HISTORIC AND DESIGN REVIEW COMMISSION

HDRC CASE NO:	2023-360
ADDRESS:	915 MASON ST
LEGAL DESCRIPTION:	NCB 1267 BLK 3 LOT S 105 FT OF 7
ZONING:	R-6, H
CITY COUNCIL DIST.:	2
DISTRICT:	Government Hill Historic District
APPLICANT:	Michael Krause/Mychals Designs LLC
OWNER:	Sevda Johnson/SEVHAS INVESTMENTS LLC
TYPE OF WORK:	Construction of a rear addition, door replacement, fenestration modifications, and porch modifications
APPLICATION RECEIVED:	November 02, 2023
60-DAY REVIEW:	January 01, 2024
CASE MANAGER:	Jessica Anderson
REQUEST:

The applicant requests a Certificate of Appropriateness for approval to:

1 FRONT VIEW
1/4" = 1'-0"

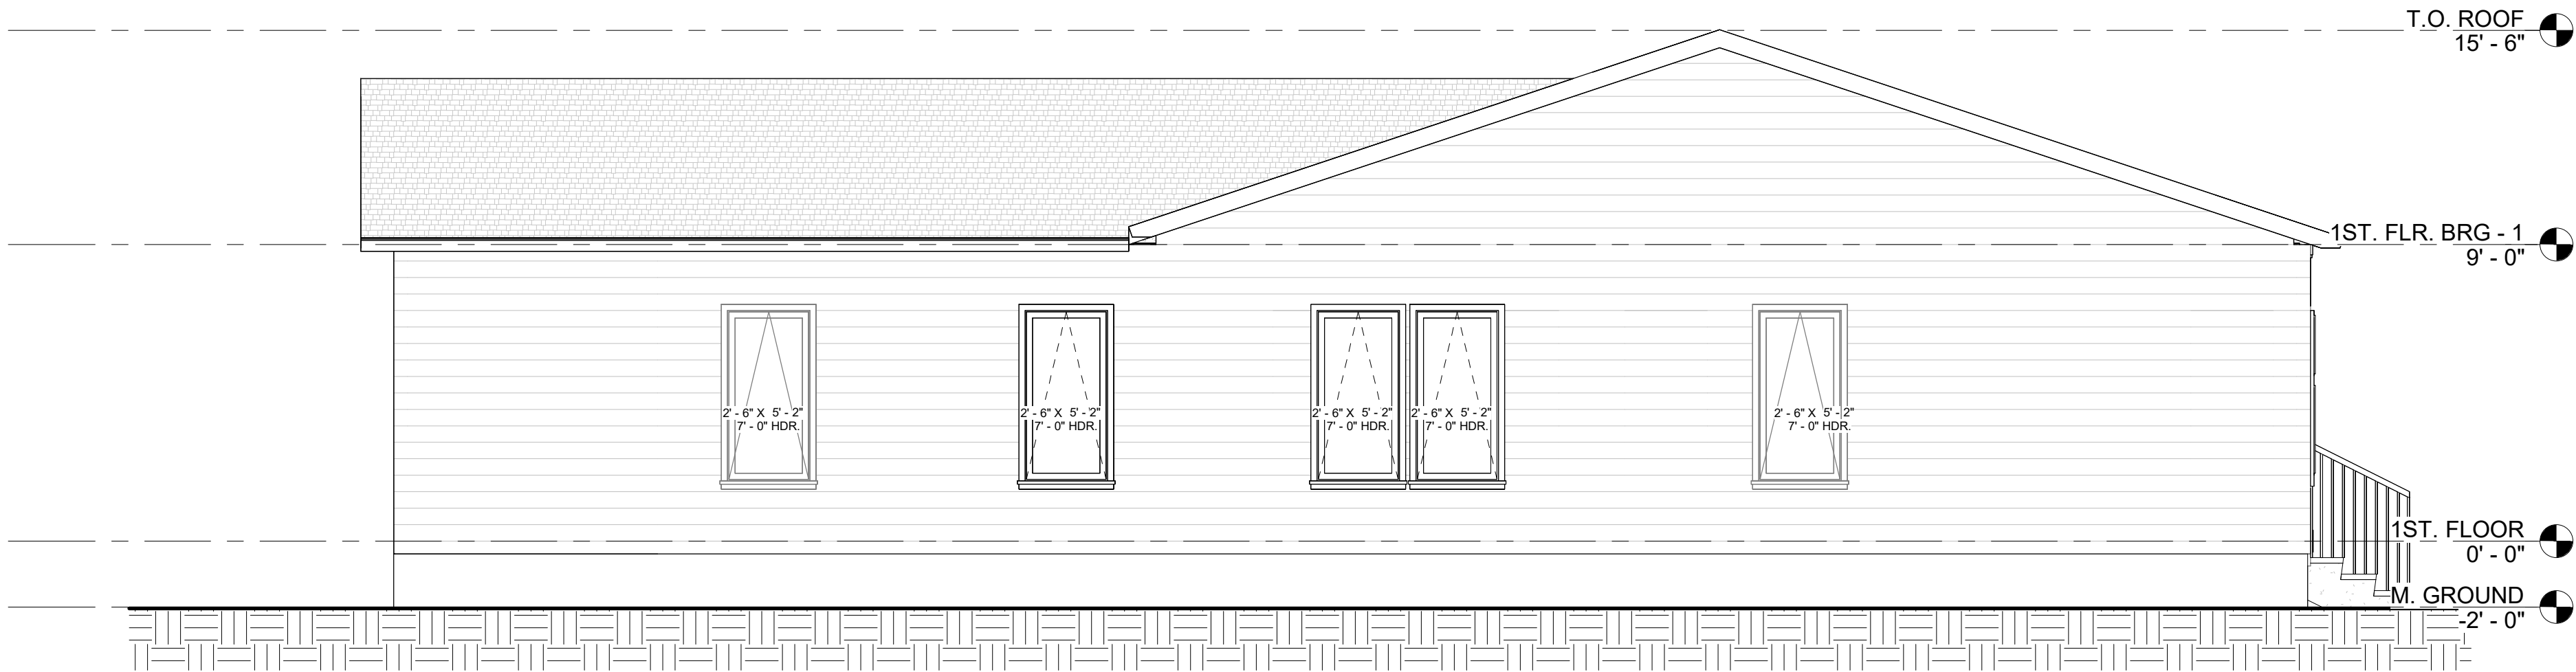
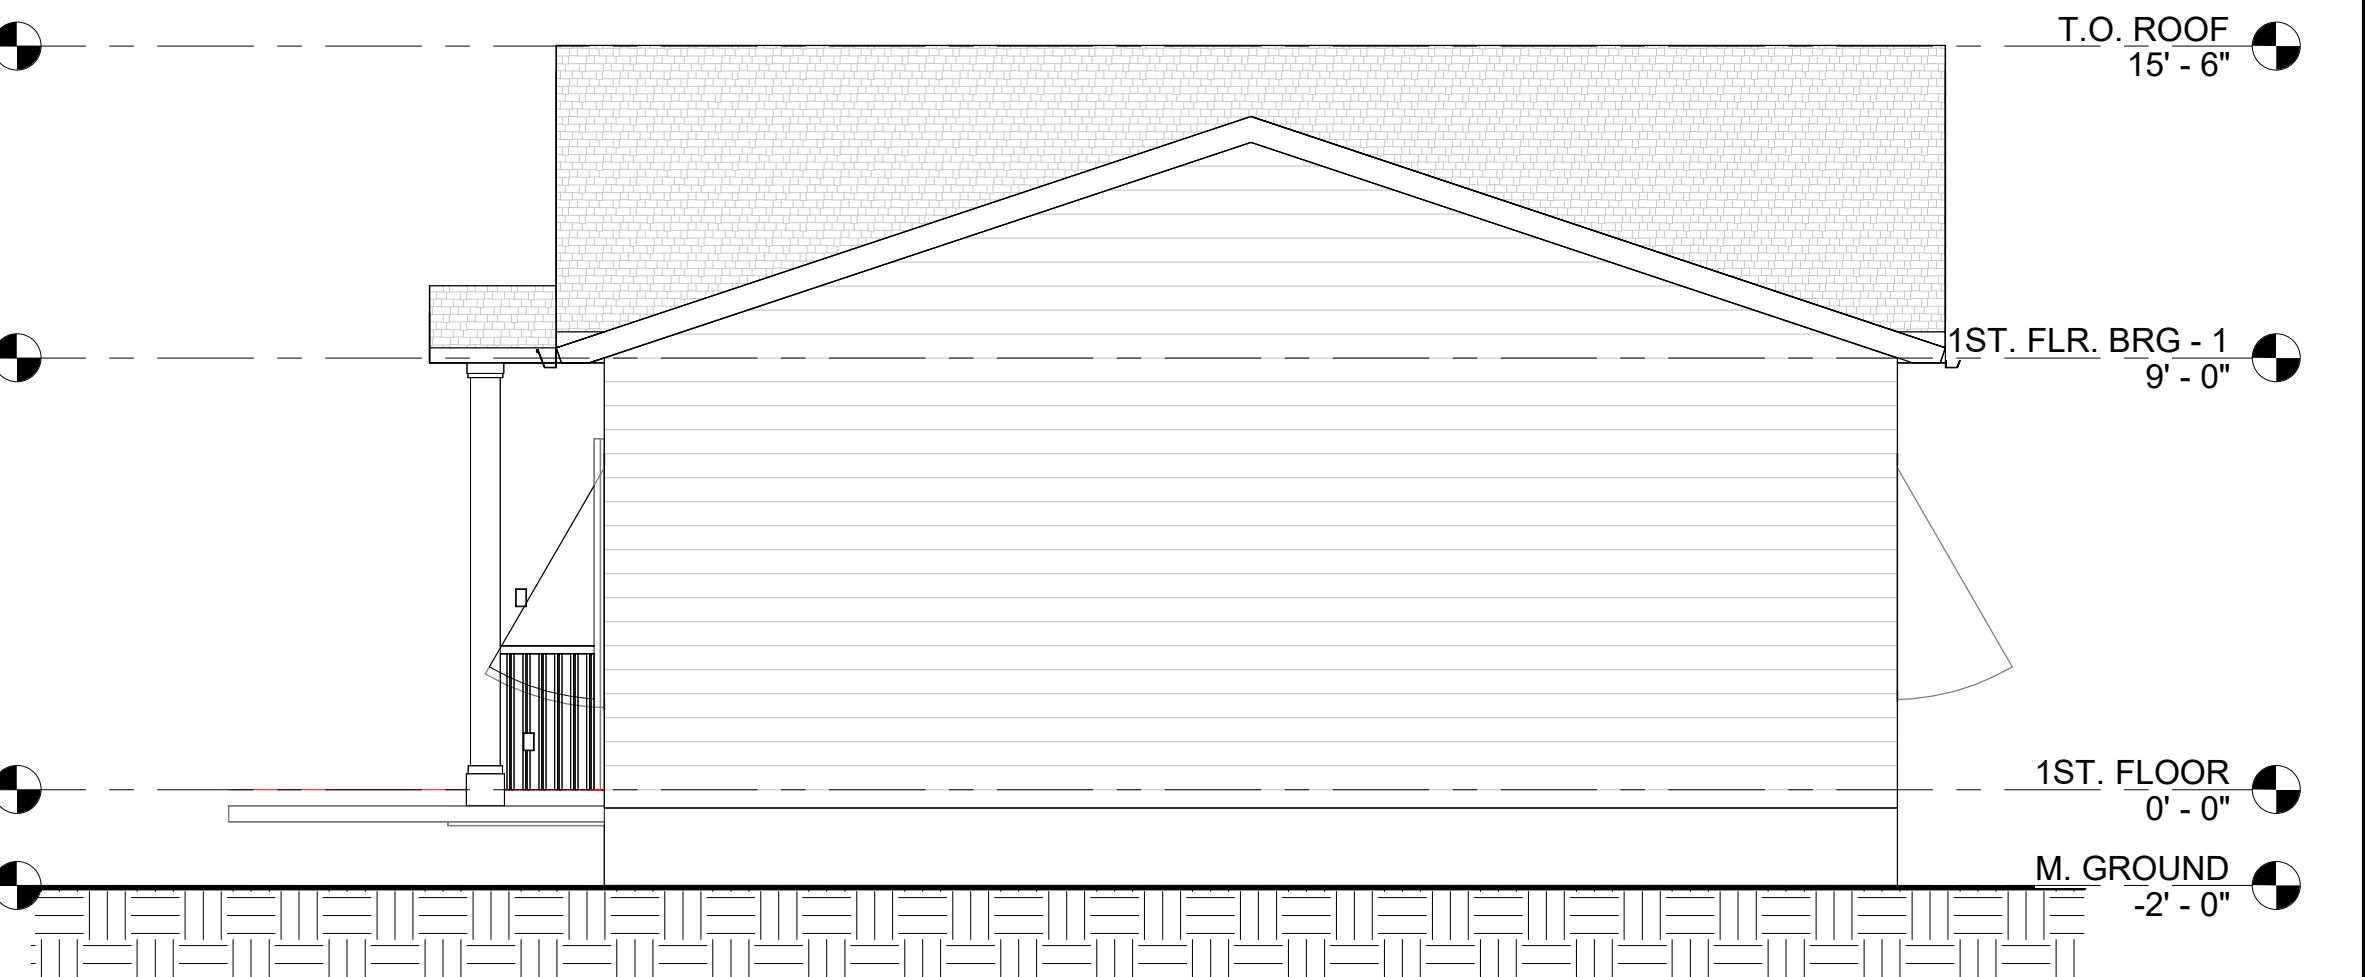
Alterations 7.A.i says to preserve existing porches, balconies, and porte-cocheres. The metal posts and railing do not conform to the style or period of construction of the house, and staff finds replacement with new square columns and railing generally appropriate. However, the applicant must provide measured drawings and materials information for the proposed new columns. The proposed columns should be wood, no wider than 6" square, and feature both capital and base trim and chamfered corners. The new railing should feature both top and bottom rails and a simple design that does not detract from the historic structure and be raised off the deck surface.

- g. **WINDOWS:** The applicant proposes to infill, modify, and add windows on the east and west elevations of the existing house. Historic Design Guidelines for Exterior Maintenance and Alterations 6.A.i says to preserve existing window and door openings. Avoid enlarging or diminishing to fit stock sizes or air conditioning units. Avoid filling in historic door or window openings. Avoid creating new primary entrances or window openings on the primary façade or where visible from the public right-of-way. Staff finds that the request to infill, modify, and add windows to the existing house does not conform to guidelines. All existing windows on the house be retained and repaired, except where they are removed on the north elevation for the proposed addition.

- h. **WINDOWS (CONSTRUCTION DRAWINGS):** The drawings submitted by the applicant show conditions that are not part of the request, namely the inclusion of awning windows on the east and west elevations. Should the HDRC find infill, modification, and/or addition of windows on the existing house appropriate, the applicant must submit accurate measured drawings, an annotated window schedule, interior and exterior photos of windows requested for replacement, and complete manufacturer's specifications and a cut sheet for the proposed new window product.

- v. That the applicant submits measured drawings and materials information for the proposed new columns.
- vi. That the proposed columns are wood, no wider than 6" square, and feature both capital and base trim and chamfered corners.
- vii. That the new railing be constructed of wood, feature both top and bottom rails and a simple design that does not detract from the historic structure, and be raised off the deck surface.

Staff does not recommend approval of item 4, infilling, modifying, and adding windows on the east and west elevations, based on findings g and h.

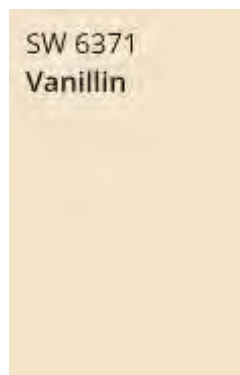
- f. **DOOR REPLACEMENT:** The applicant requests to replace the two existing front doors and one existing side door with nonconforming modern doors. Replacement products should complement the style and period of construction of the structure. Staff finds the replacement doors nonconforming.

- viii. That the applicant proposes a replacement product that compliments the style and period of construction of the structure, namely a Craftsman-style, fully wood door product.
